Project: Santa Sophia School

Report: BCA Assessment Report

Reference No: 110181-BCA-r3

Date: 11 April 2019

Stair 3:

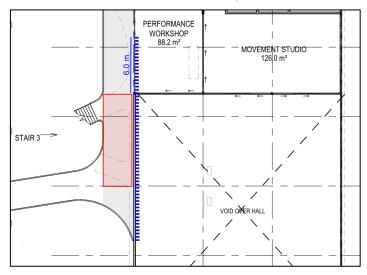
- Stair 03: Level 01 As the balcony forms part of the stair egress path to open space (bridge), any external wall with 6m of the egress path (the Performance Workshop and Hall Walls) shall be FRL 60/60/60. Hall external wall requires 60/60/60 for the length of the wall to the end of the balcony to protect egress path to open space. Any windows will be fixed closed and protected with internal wall-wetting sprinklers in accordance with C3.4 & AS2118.1-2017.
- Stair 3: Level 02 & 03 The current design has the 2m egress path along the main balcony setback 6m or more from the external wall complies.

Level 01: 6m of Performance Workshop wall requires 60/60/60 and along Hall as shown.

Stair 6:

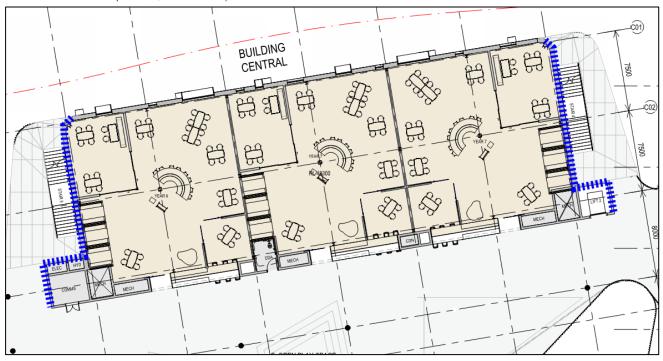
- Level 02-05: The stair and landing egress path are within 6m of the classroom external walls. Subject to further review with the Fire Engineer on stair design and proposed rationalisation of omitting protection of openings within 6m.
- Level 1: Final flight after curved mid landing which is parallel to the CELC is more than 6m from the external walls. Upper flight is within 6m of external wall and will be assessed as above.
